Building Manager: [John Cochran, john.cochran@oregonstate.edu](mailto:john.cochran@oregonstate.edu)
 Assessment Date: 2/2/2022
 Assessment Number: **10535**
 Location: Gleeson Hall Entire
 Reinspection date:

A joint fire safety inspection of the facility listed above was performed by the Environmental Health & Safety - Fire and Life Safety and the Corvallis Fire Department. These fire safety deficiencies could result in a fire or jeopardize the safety of those occupying the facility. Please see that these items are corrected immediately and no later than the scheduled reinspection date noted with this report. If you have any questions regarding this inspection, please email Brian Lilley (EH&S - Fire and Life Safety) at brian.lilley@oregonstate.edu.

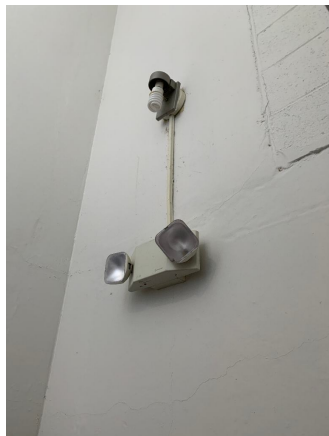
Priority code	Standard in need of attention	Reg.Reference	Location	Resp	Observations & Recommendations	Date Corrected
2	Emergency lighting shall be maintained.	2019 OFC 1031.10	Stairwell:Between 2nd & 3rd	FS	South stairs between second and third floors exit lights are out.

Room 312

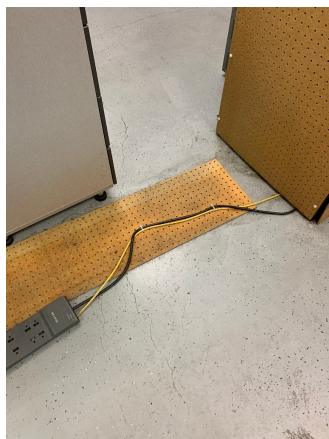
Power strips, extension cords, or any other electrical cord shall not extend through walls, ceilings, floors, under doors or floor coverings, or be subject to damage.

Provide floor cord protector across aisle.

Throughout

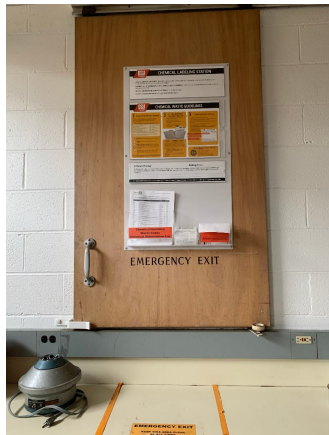
2	Additional Findings:		Throughout:inside	DEPT	Remove "EMERGENCY EXIT" signage from sliding dividers between lab spaces - 2019 OFC 3804.1.1.5	
---	----------------------	--	-------------------	------	--	--
